BLOCKS 5&6
CIRCLE SQUARE (FORMERLY KNOWN AS BBC SITE)
OXFORD ROAD, MANCHESTER

Description of Non-Material Amendments July 2021

Extract of CSAL-PLA-ZT-XX-DR-L-0001-Masterplan Plots 5&6-C05
Masterplan

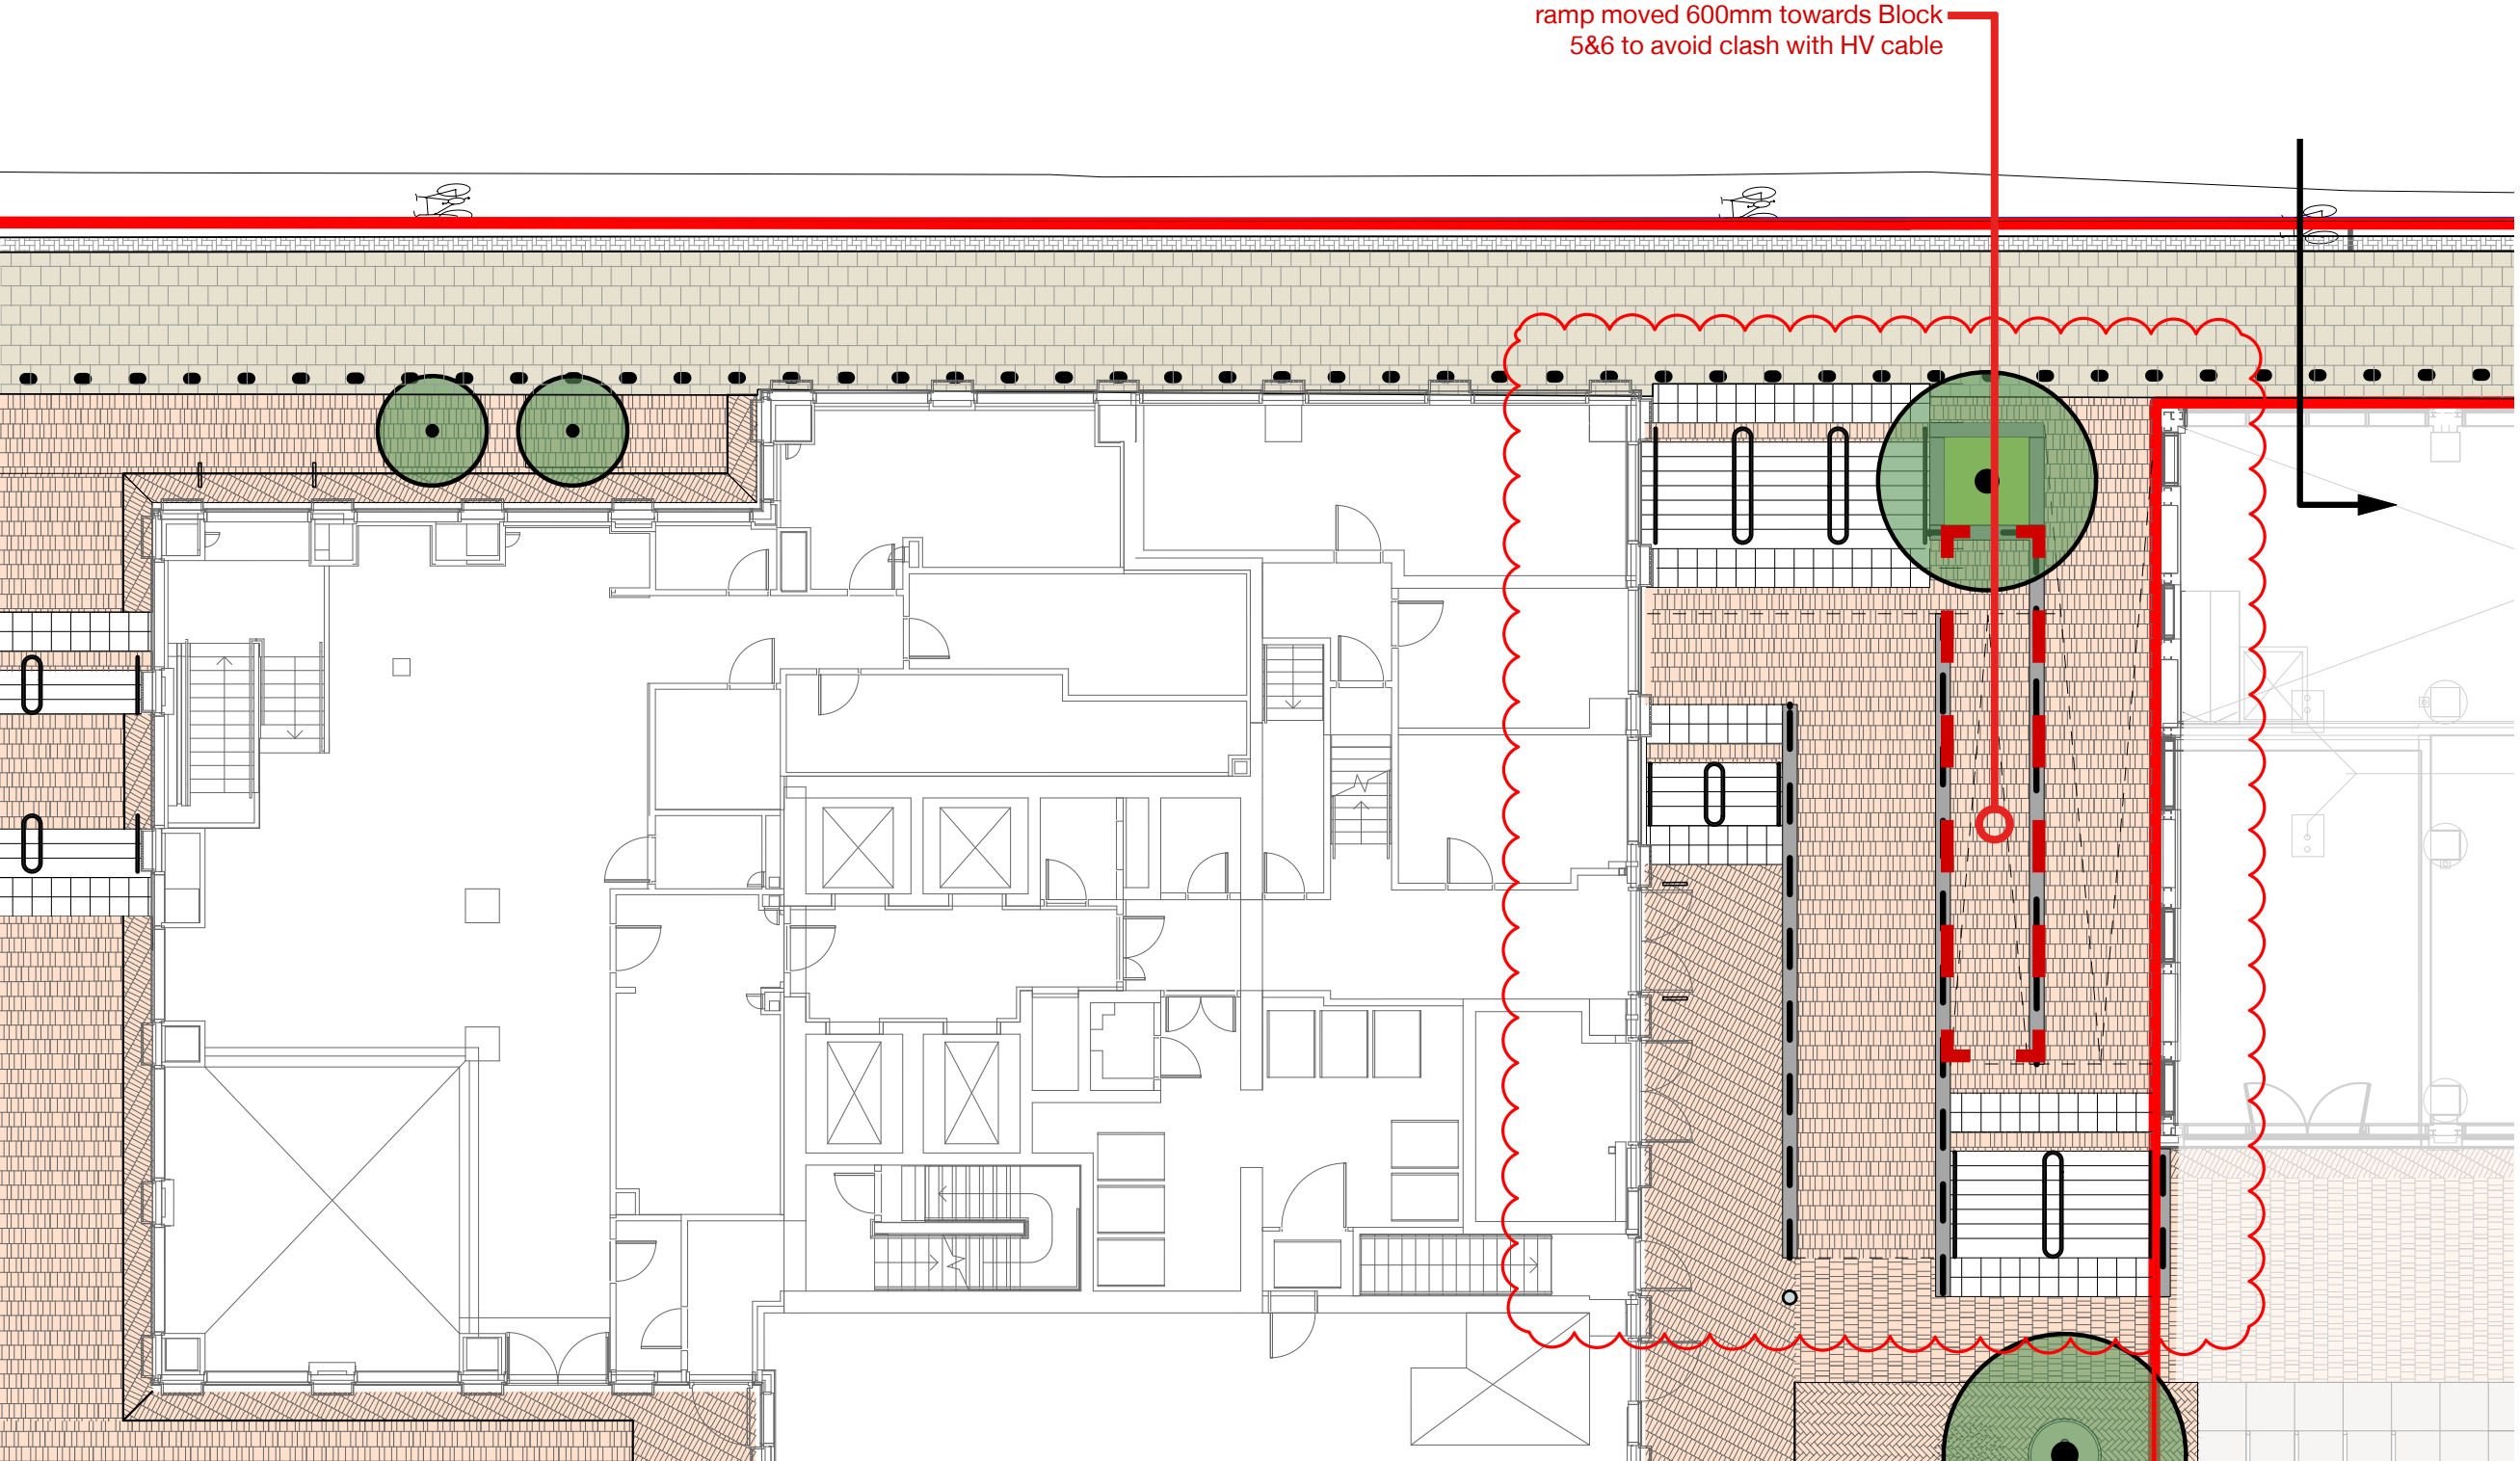
- Access from Charles St between Block 6 & 9
 - To prevent a clash with HV cable, proposals are to widen ramp and reduce width of staircase

Extract of CSAL-PLA-ZT-XX-DR-L-0001-Masterplan Plots 5&6-C08
Masterplan
